Sizing, Selection, and Installation of Pressure-relieving Devices

Part II—Installation

API STANDARD 520, PART II
~~SEVENTH~~ EIGHTH EDITION, ~~OCTOBER~~ XXXXX ~~2020202X~~202X

DRAFT - FOR COMMITTEE REVIEW

Figure 6—Typical Pressure-relief Valve Installation with Vent Pipe

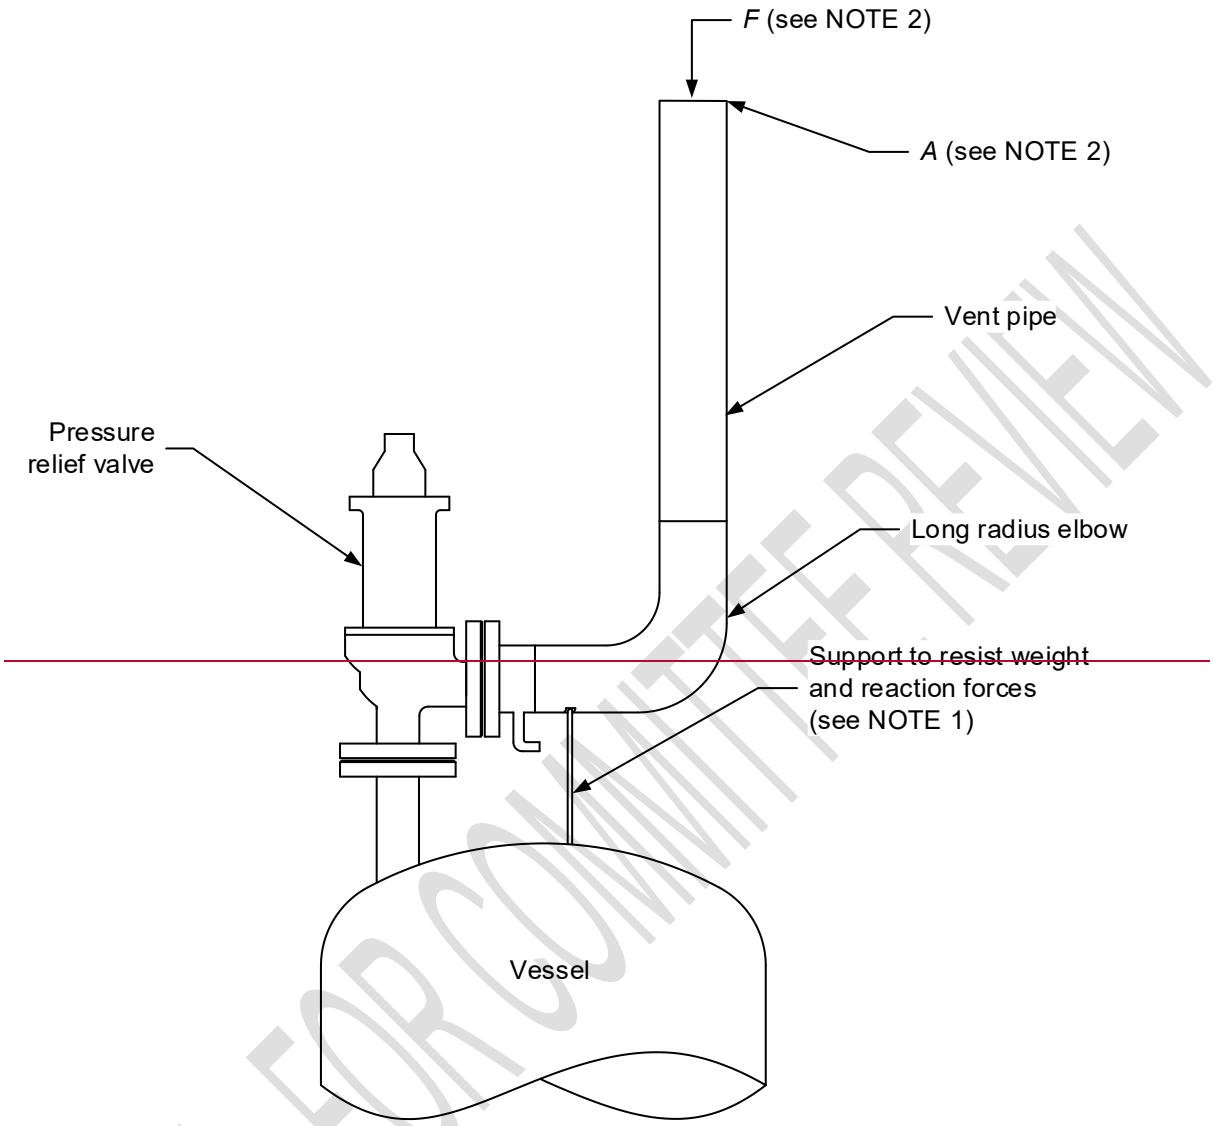
~~NOTE 1 The support should be located as close as possible to the centerline of the vent pipe.~~See 5.8.1.2 ~~for location of support.~~

~~NOTE 2 *F* = reaction force; *A* = cross-sectional area.~~

Figure 9—Typical Pilot-Operated Pressure-relief Valve Installation

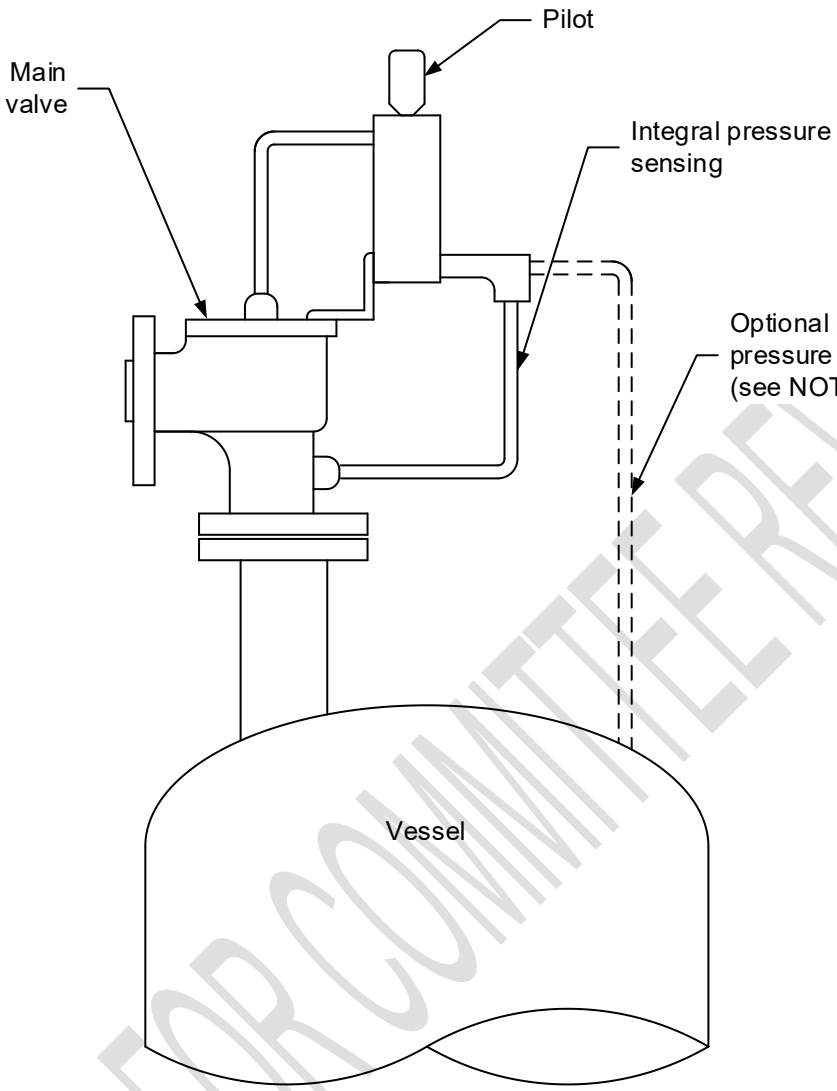
7.3.9.1 Remote sensing permits the pilot to sense system pressure at a location that most accurately reflects the actual pressure of the protected system. Remote sensing will mitigate the effect of excessive inlet pressure losses due to the inlet piping configuration (see ~~Figure 9~~ NOTE See 7.3.9.

~~NOTE See 7.3.9.~~

Figure 11—Typical PRD Installation for 100% Spare Relieving Capacity

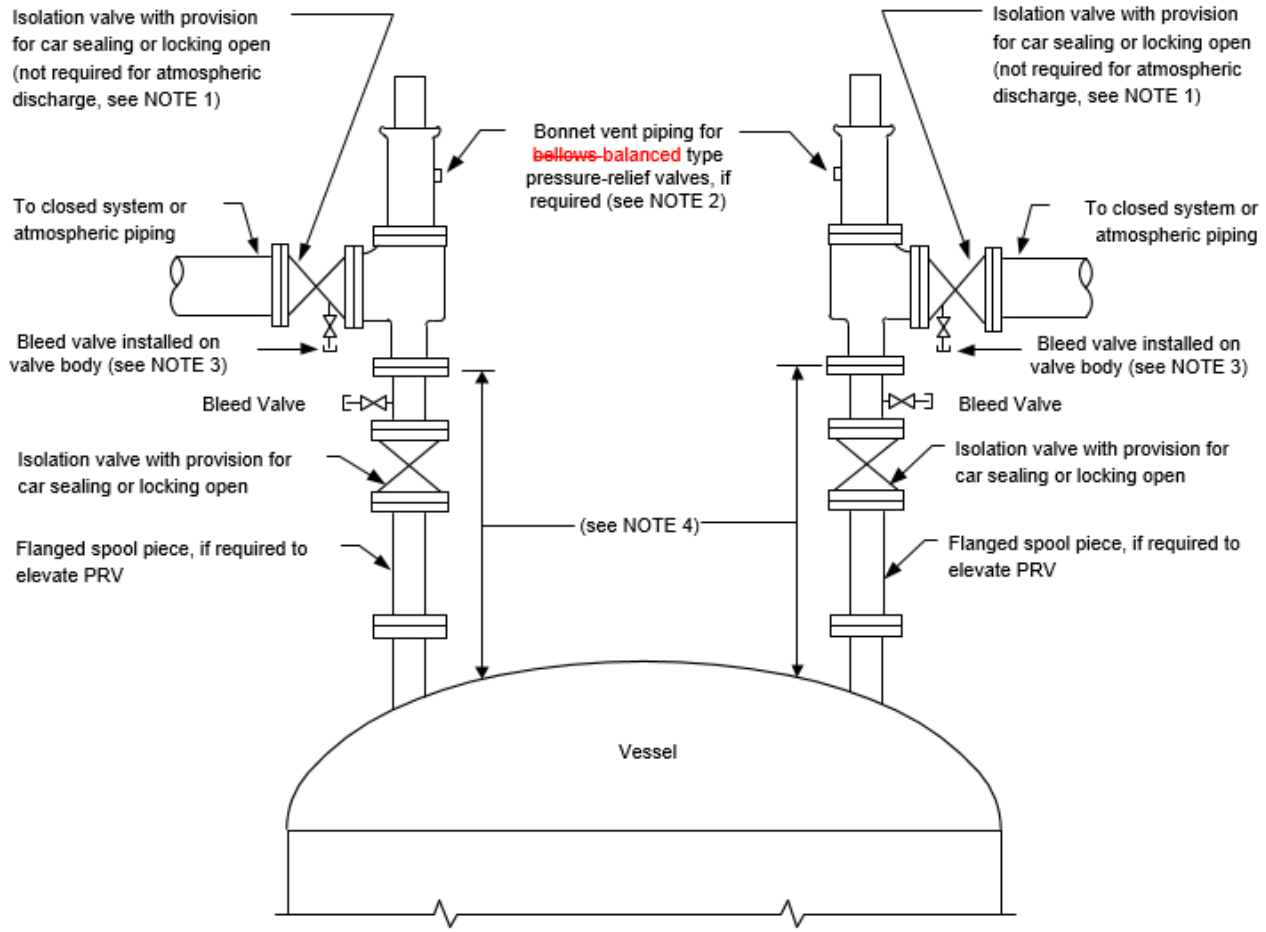
~~NOTE 1 See Section 8 for the use of isolation valves in pressure-relief system piping.~~
~~NOTE 2 See Section 10.~~
~~NOTE 3 Alternatively, a pipe spool with bleed may be provided.~~
~~NOTE 4 See 7.3 for detailed discussion on inlet pressure drop.~~

NOTE 1 See Section 8 for the use of isolation valves in pressure-relief system piping.
NOTE 2 See Section 10.
NOTE 3 Alternatively, a pipe spool with bleed may be provided.
NOTE 4 See 7.3 for detailed discussion on inlet pressure drop.

Figure 16—Typical Flare Header Block Valves

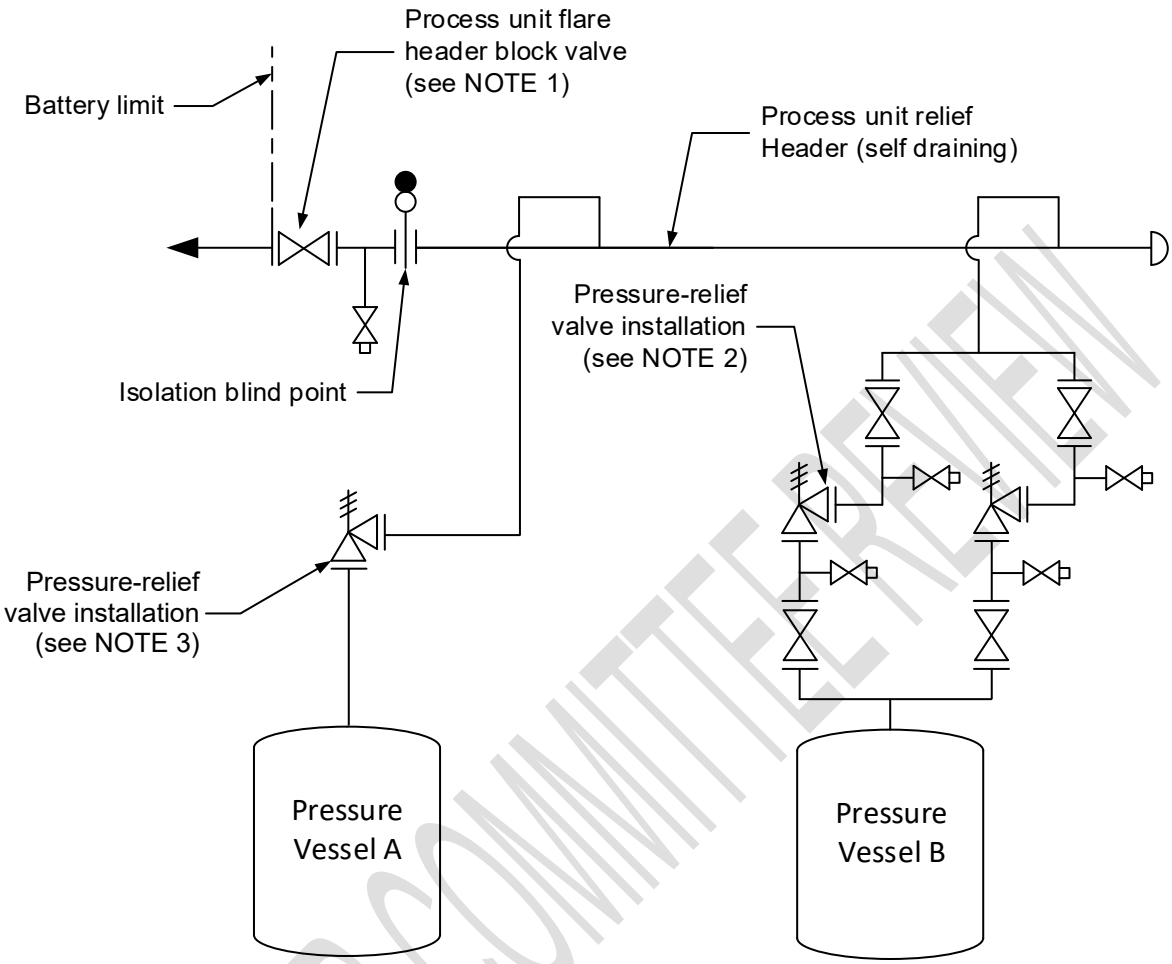
~~NOTE 1 See 8.48.3.~~
~~NOTE 2 See Figure 11 and Figure 12.~~
~~NOTE 3 See Figure 3 and Figure 10.~~

NOTE 1 See 8.3.
NOTE 2 See Figure 11 and Figure 12.
NOTE 3 See Figure 3 and Figure 10.

Figure 17—Typical Isolation Block Valves for Spare Compressor

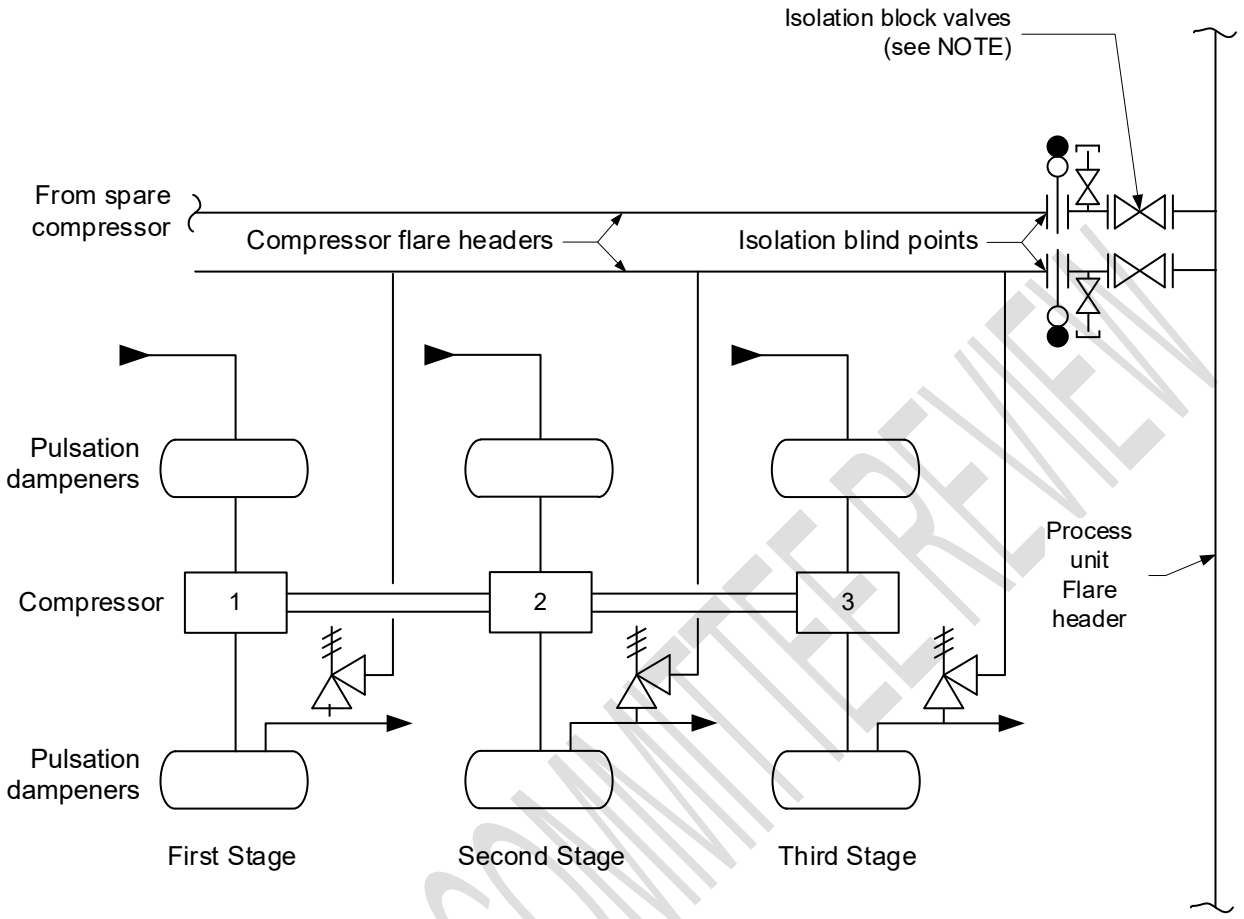
~~NOTE See 8.4~~8.3.

Figure 20—Bonnet Vent for Balanced Pressure-relief ~~Bellows~~ Valves Handling Vapor with Remote Vent Location

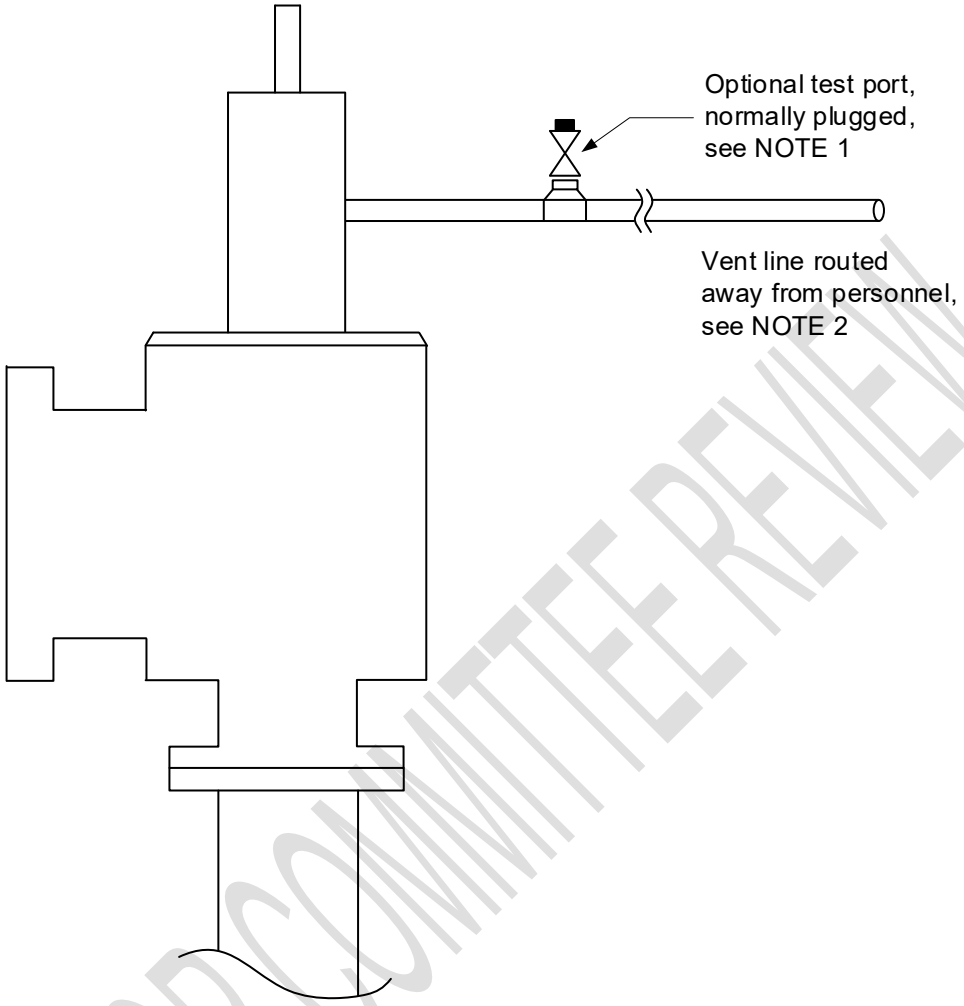
~~NOTE 1 A test port may be provided to check for internal balancing element bellows leakage or plugged vent line.~~
~~NOTE 2 See 10.3.3.~~

Figure 22—Bonnet Vent for Balanced Pressure-relief ~~Bellows~~ Valves Handling Liquids or Flashing Liquid and Vapor with Remote Vent Location

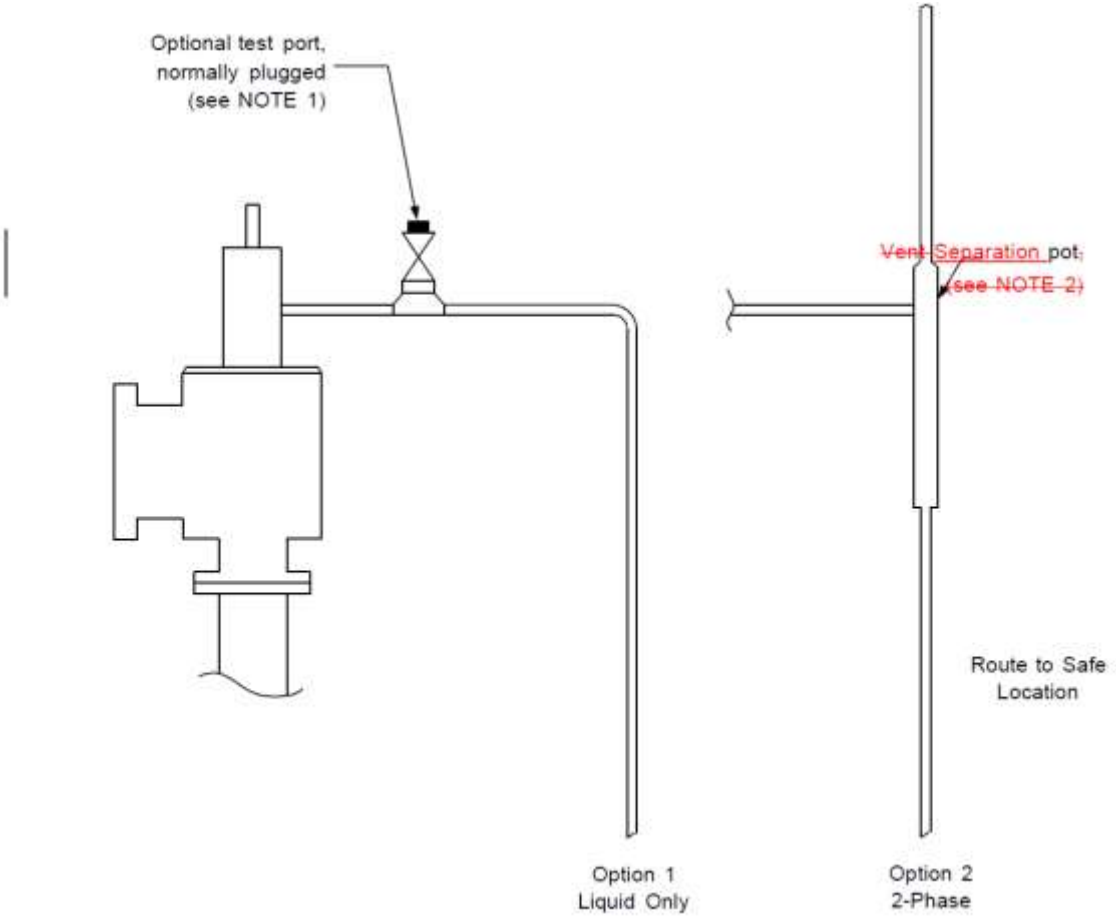
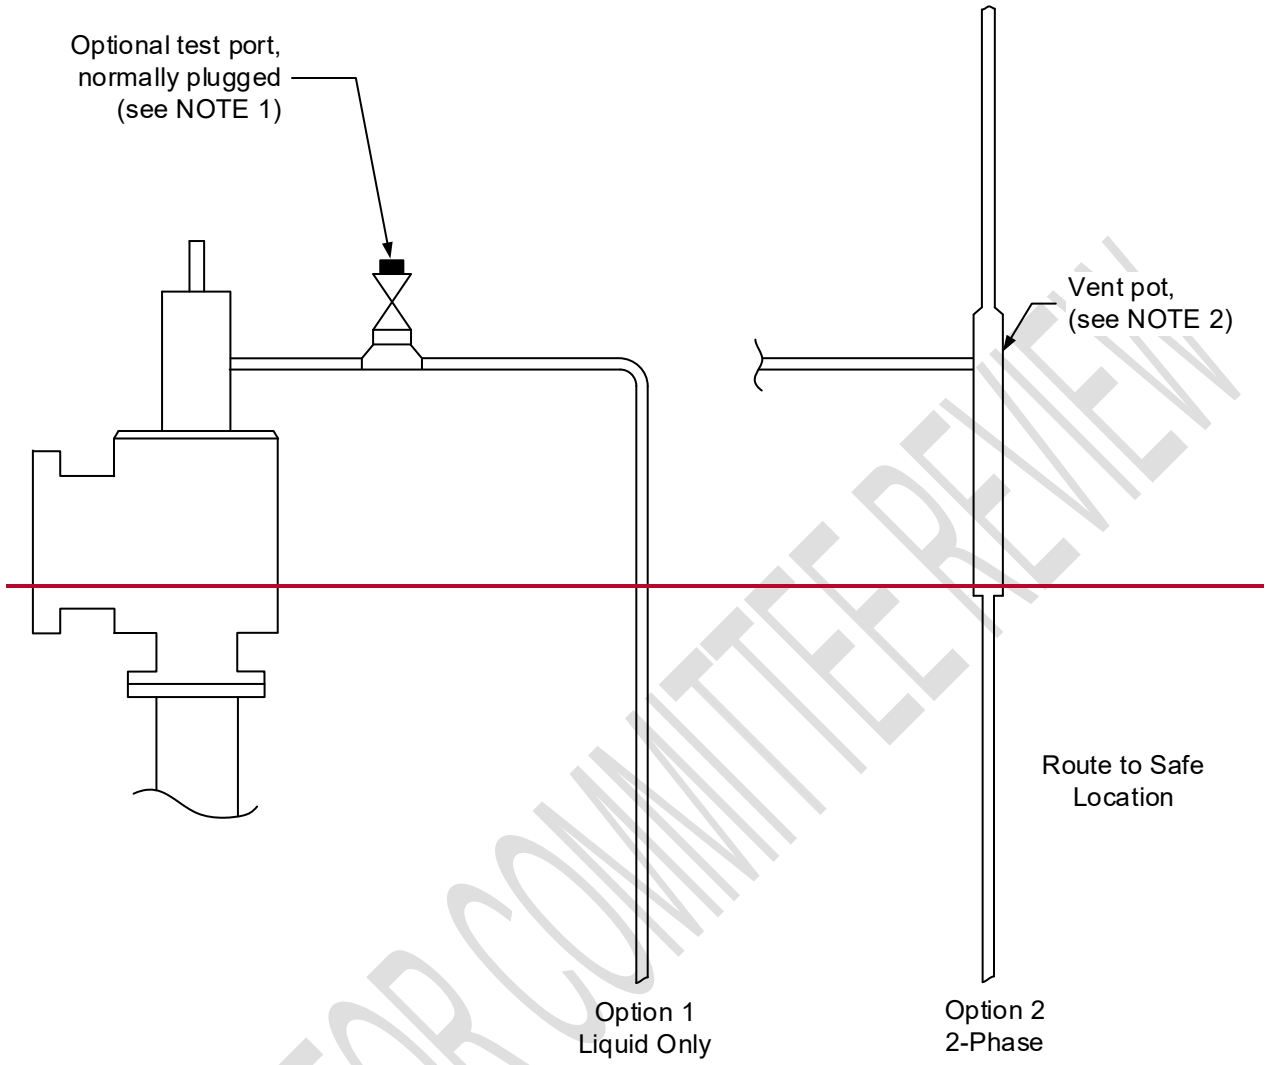
~~NOTE 1 A test port may be provided to check for bellows internal balancing element leakage or a plugged vent line.~~

~~Editor's note: Change "See Note 2" to "See 10.3.5"~~

Editor's note: Change "See Note 2" to "See 10.3.5"

NOTE 1 A test port may be provided to check for bellows leakage or plugged vent line.
NOTE 2 For flashing liquid and vapor, the pot must be large enough to disengage the liquid.
